**Request for Proposal, 16MCO11**  
**In response refer to RFP No. 16MCO511 Addendum 3 (three)**  
**March 4, 2016**

## ADDENDUM

Midland County Amphitheatre  
**Concrete Bid Package**  
Midland, Texas

ADDENDUM NO. 3

**1 SITE PLAN**  
SD-02  
1" = 20'-0"

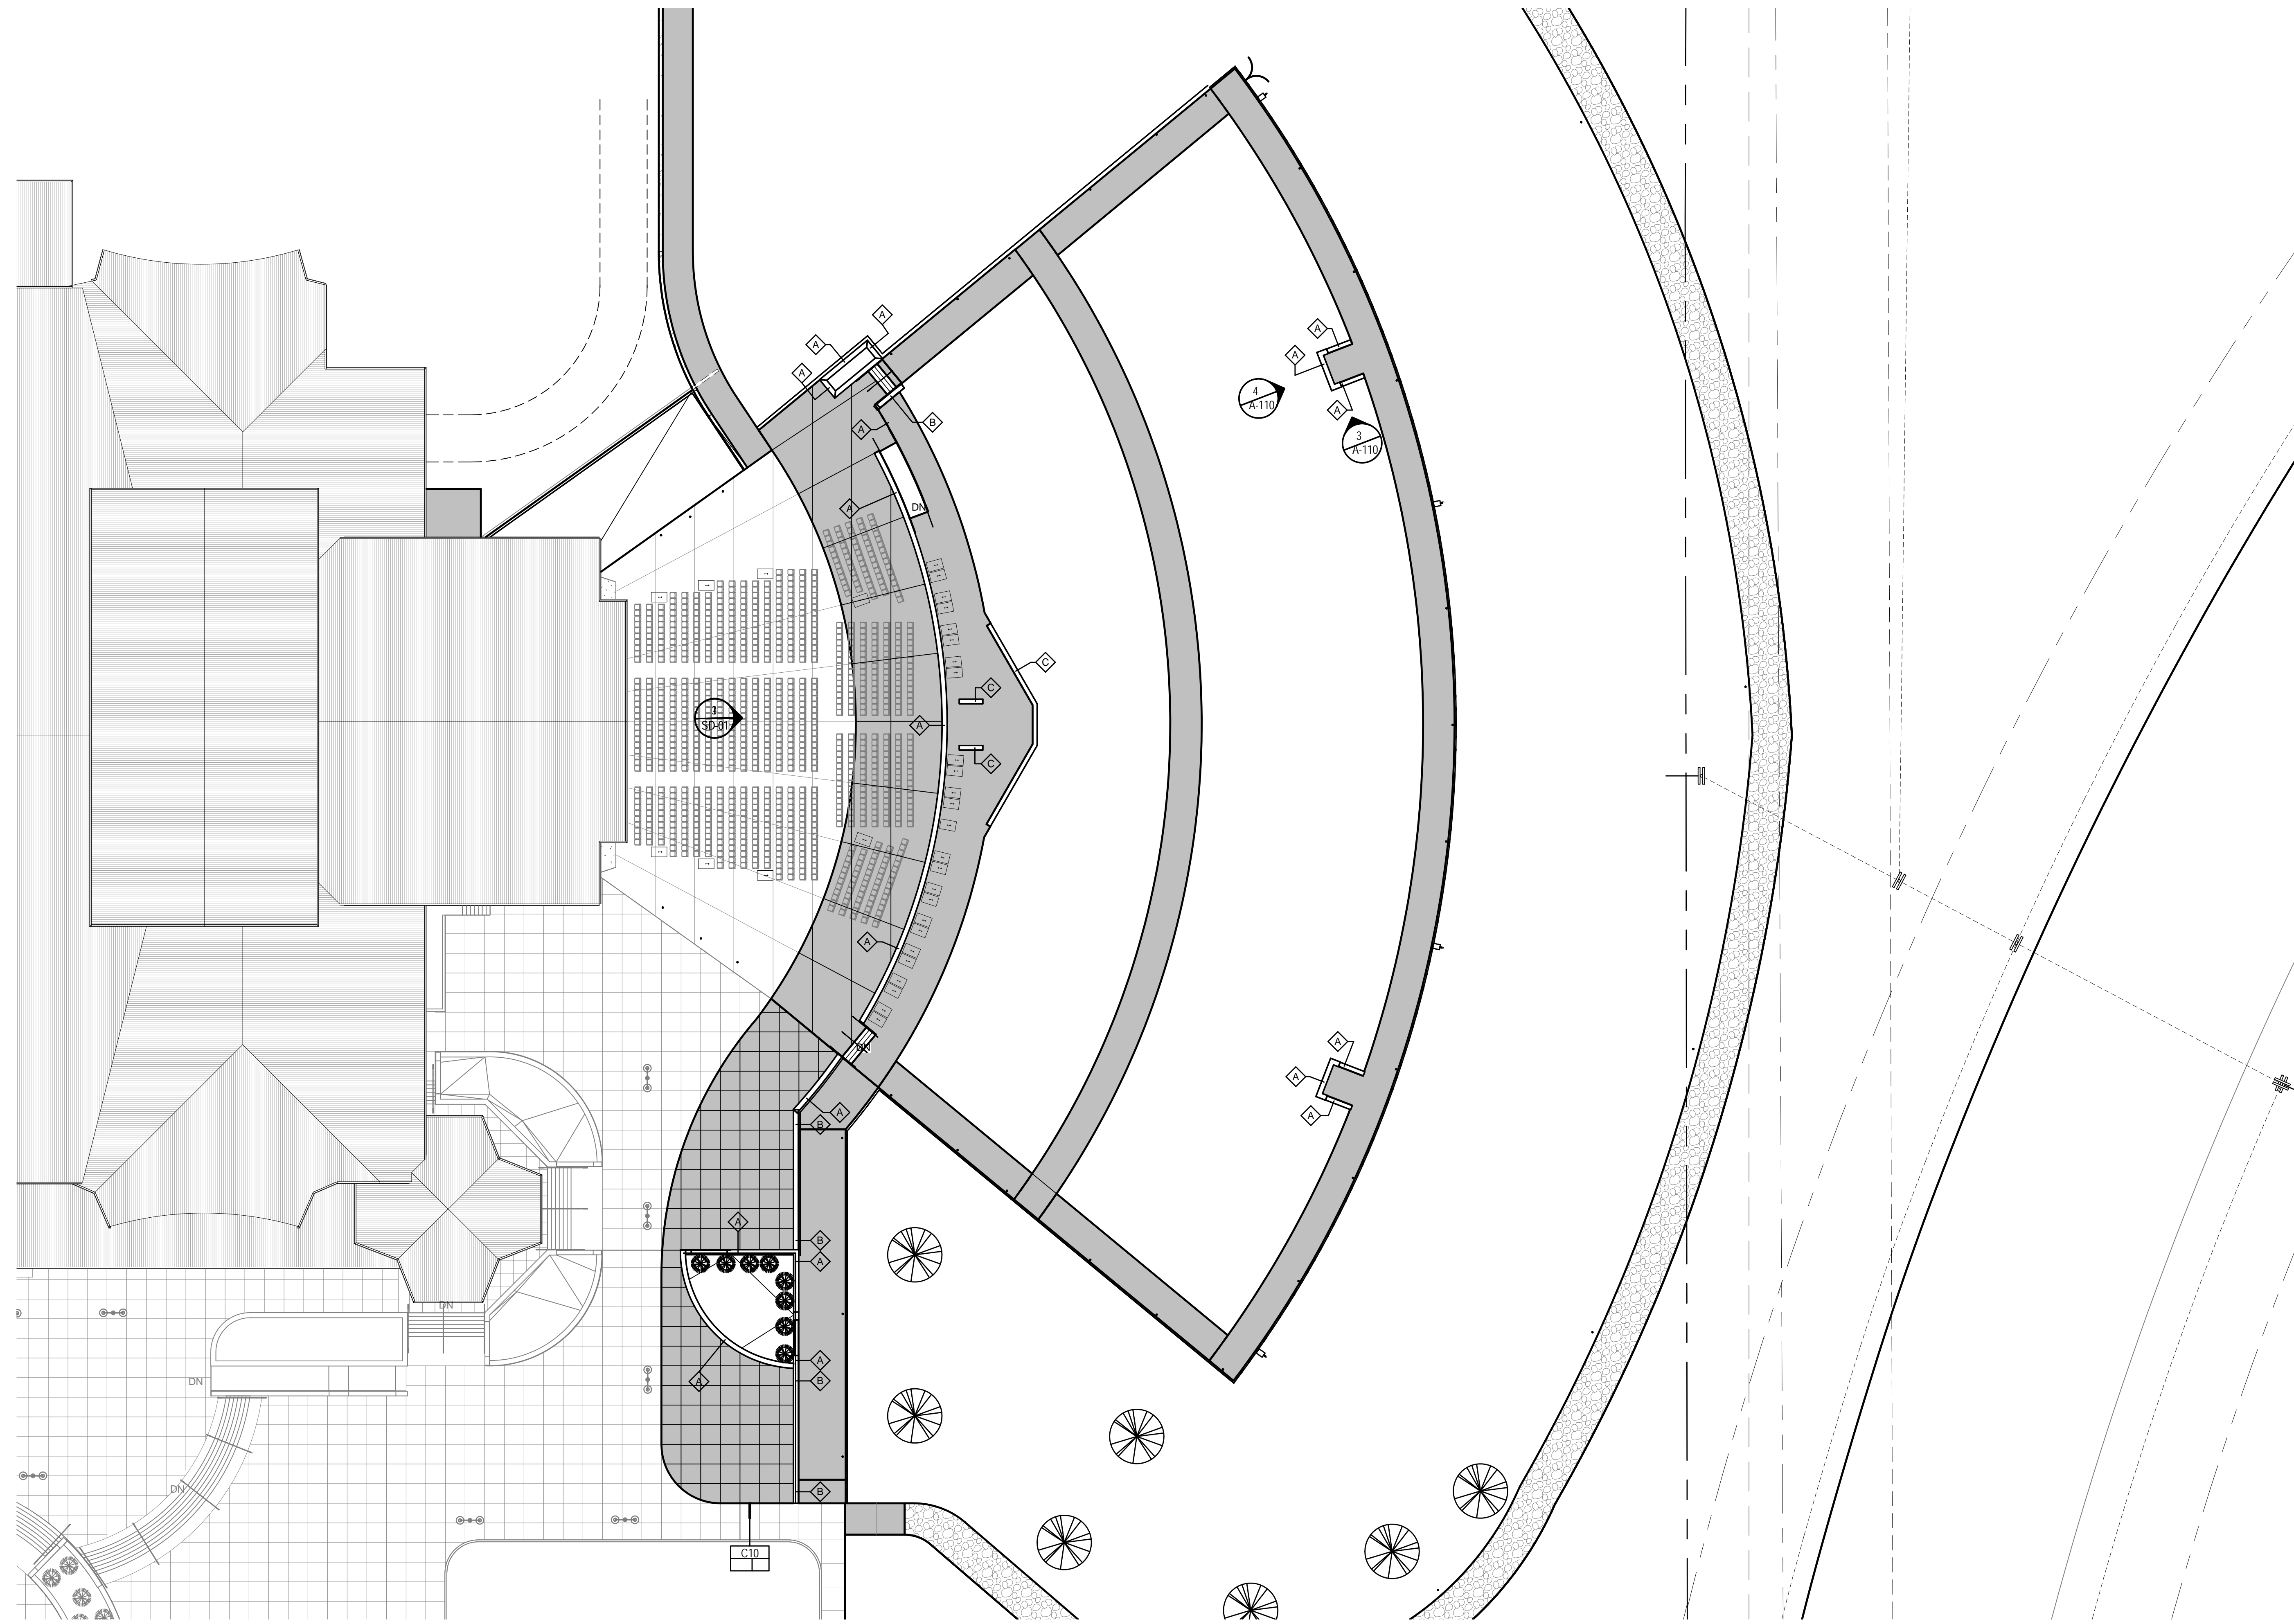
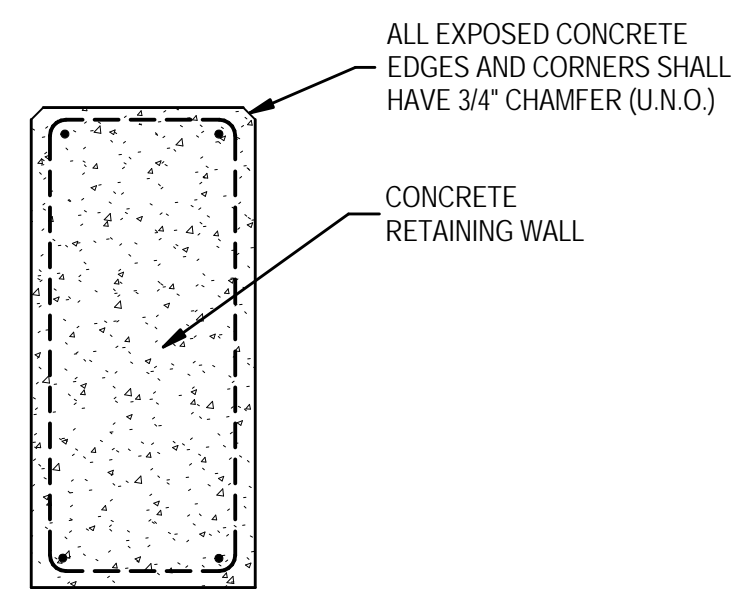
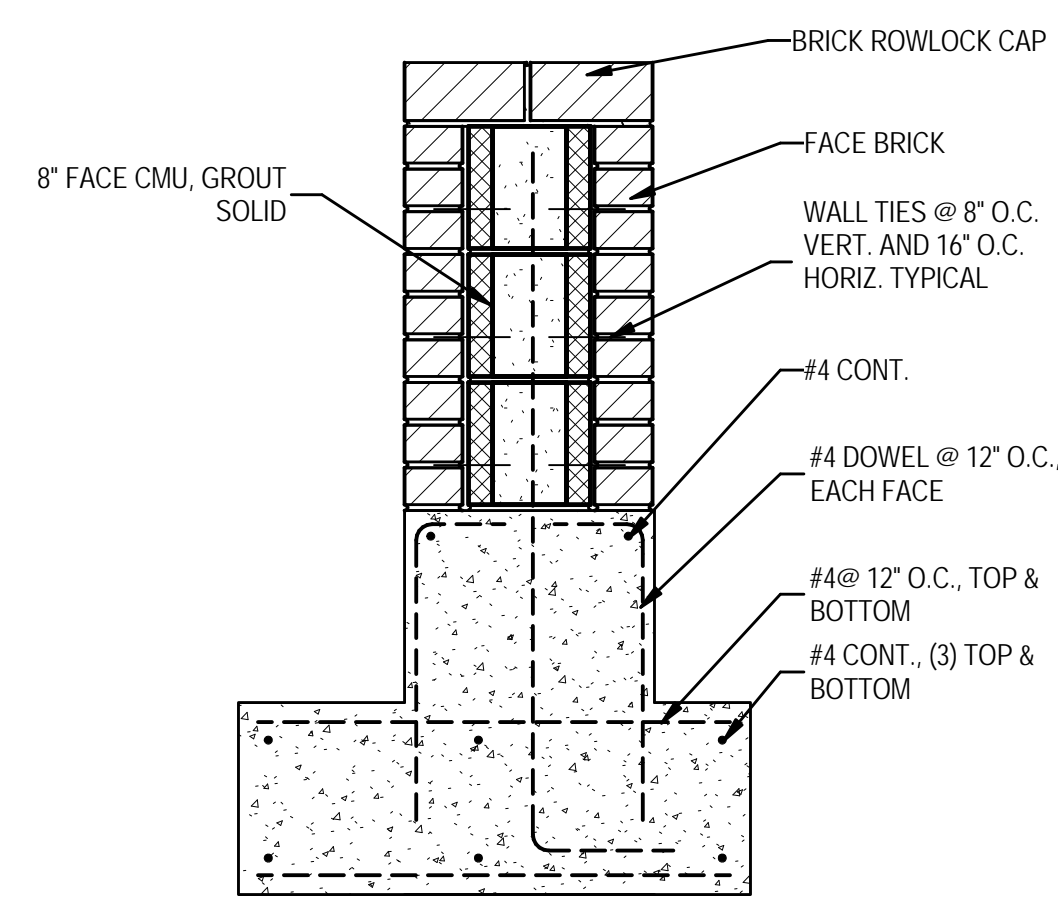
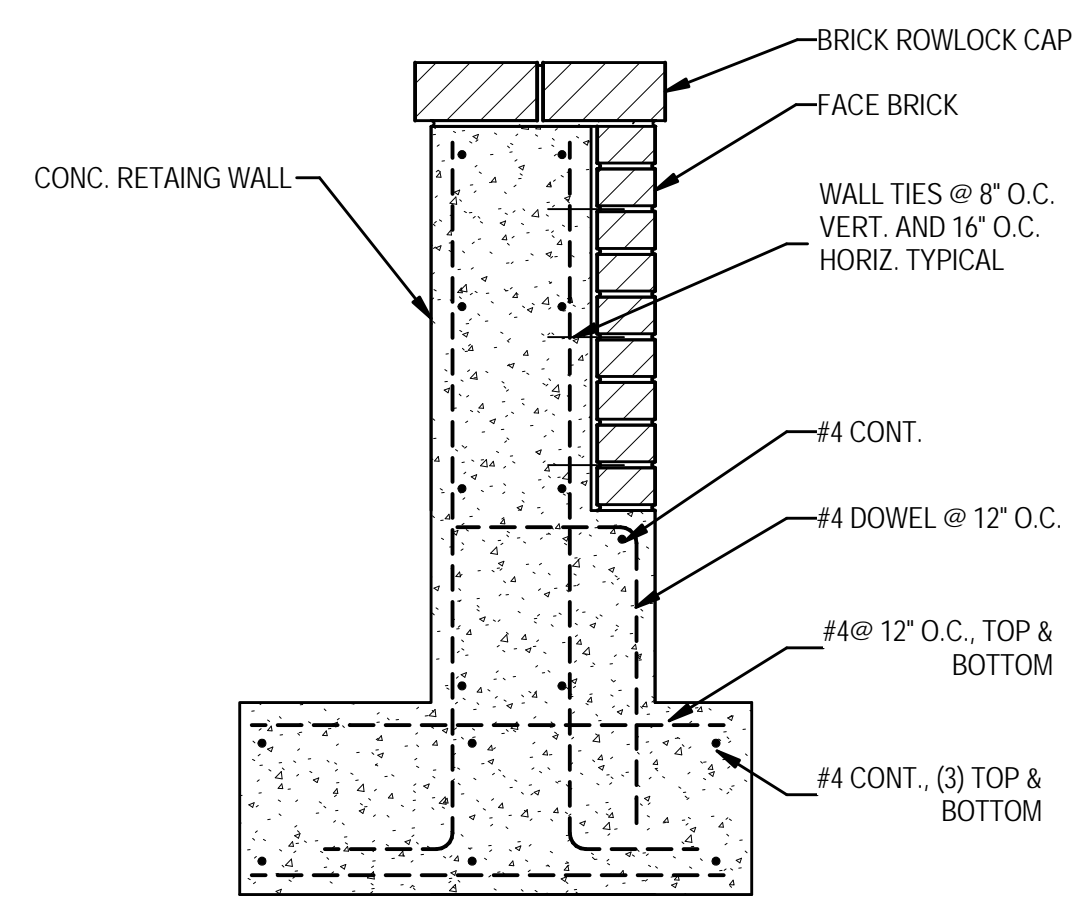
Item 2 Re: Construction Documents; Architectural Sheet SD-02; Clarification of wall types and limits. Wall types and locations are shown on this sheet.
